# Public

900 S Reconstruction

January 9, 2019 12:42 PM MST

Q6 - What do you think of the recommended redesign of the Gilmer Drive intersection at 1100 East / 900 South? To what extent do you agree or disagree with our recommended design?

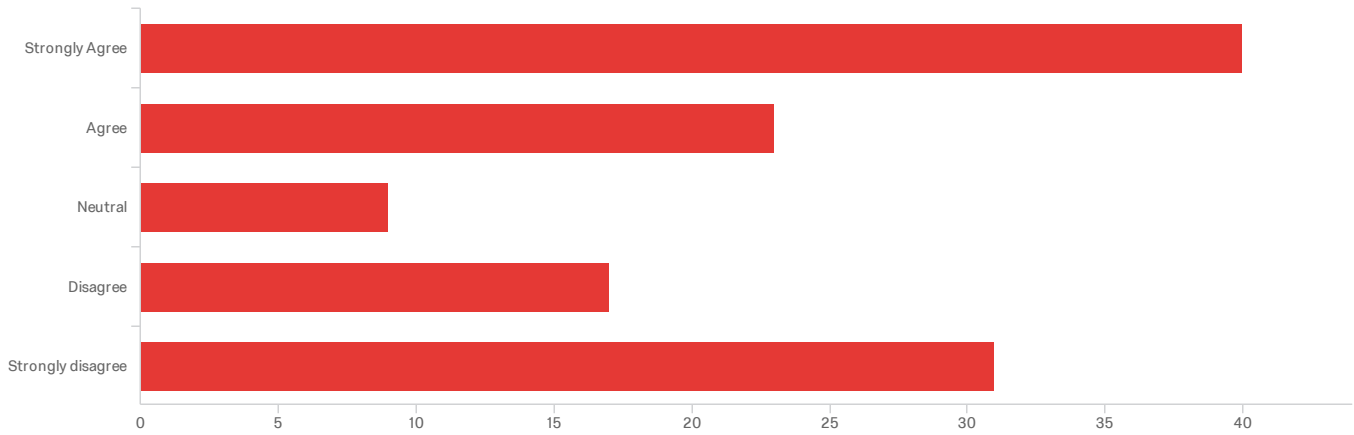
#	Field	Choice Count
1	Strongly Agree	33.33% 40
2	Agree	19.17% 23
3	Neutral	7.50% 9
4	Disagree	14.17% 17
5	Strongly disagree	25.83% 31
		120
